[Docket No. 2002–NM–128–AD; Amendment 39–13269; AD 2003–16–16]

Airworthiness Directives; Boeing Model 747–400 Series Airplanes Equipped With General Electric Model CF6–80C2 Series Engines

ACTION: Final rule.

Electro-Mechanical Brake and CDU Cone Brake Torque Check
Figure 1

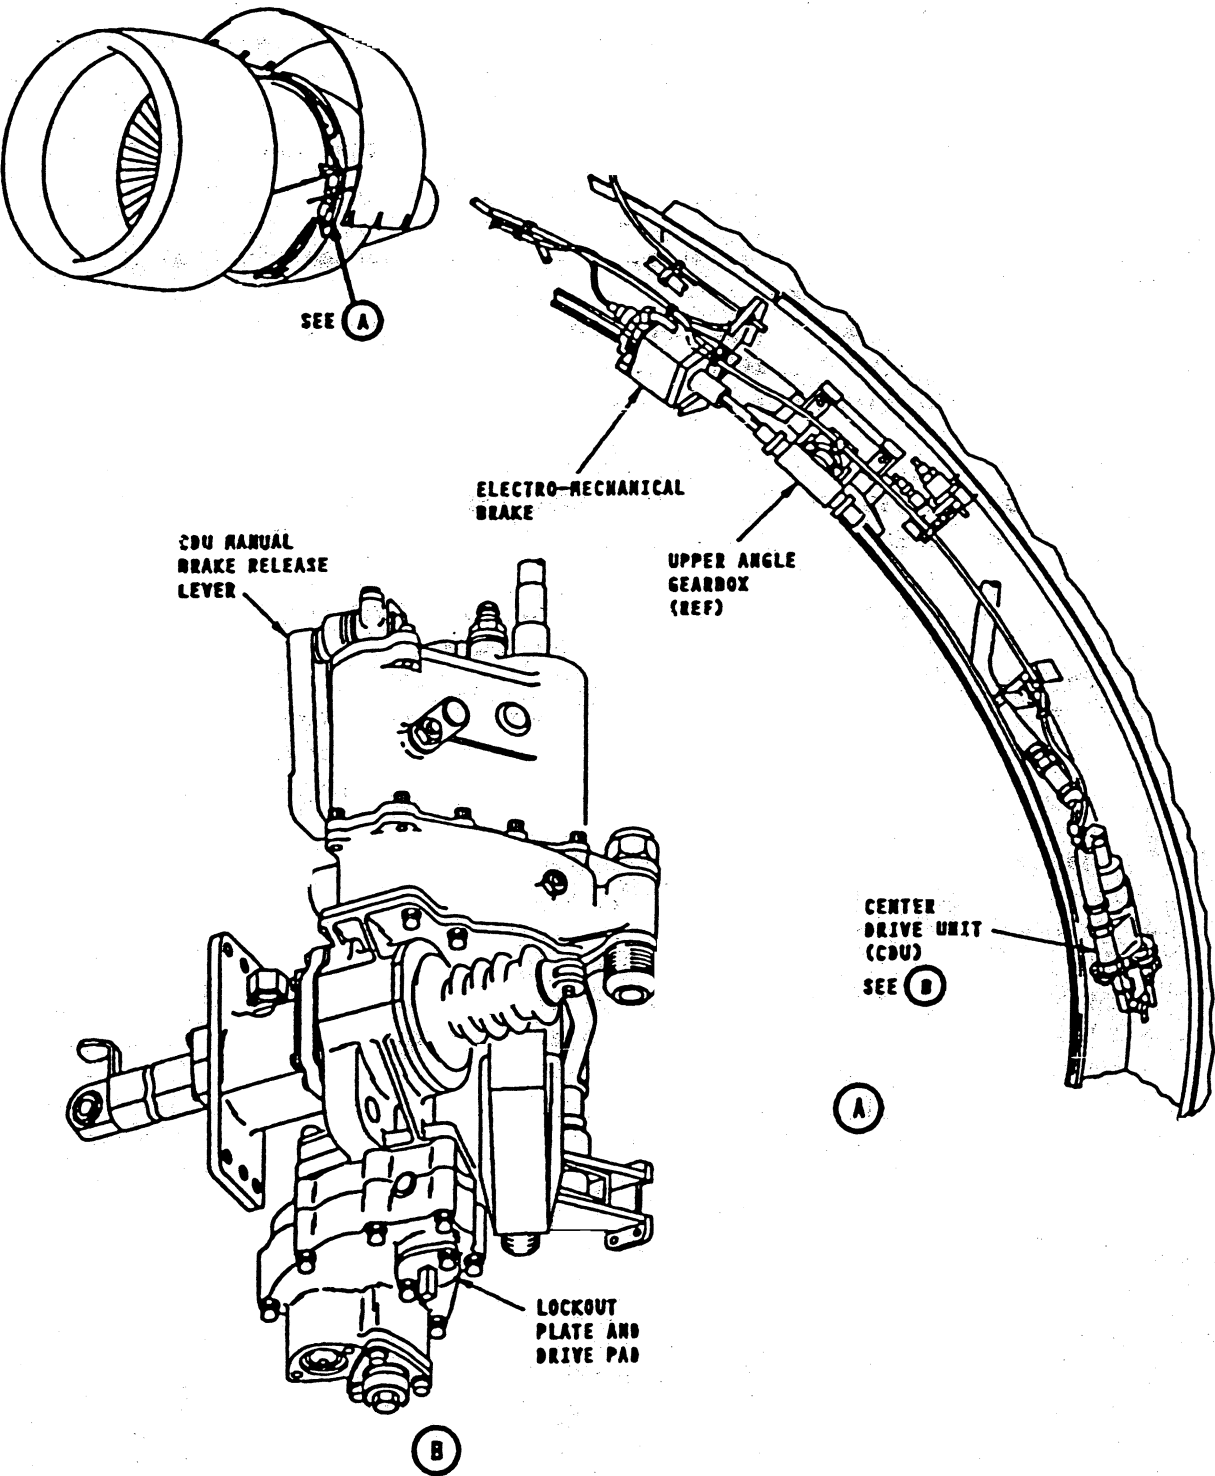
2. CDU cone brake check (Figure 1):

(6) Install a 1/4-inch drive and a dial-type torque wrench into the CDU drive pad.

(7) Turn the torque wrench to try to manually extend the translating cowl until you get at least 15 pound-inches.

Note: The cone brake prevents movement in the extend direction only. If you try to measure the holding torque in the retract direction, you will get a false reading.

(8) If the torque is less than 15 pound-inches, you must replace the CDU.
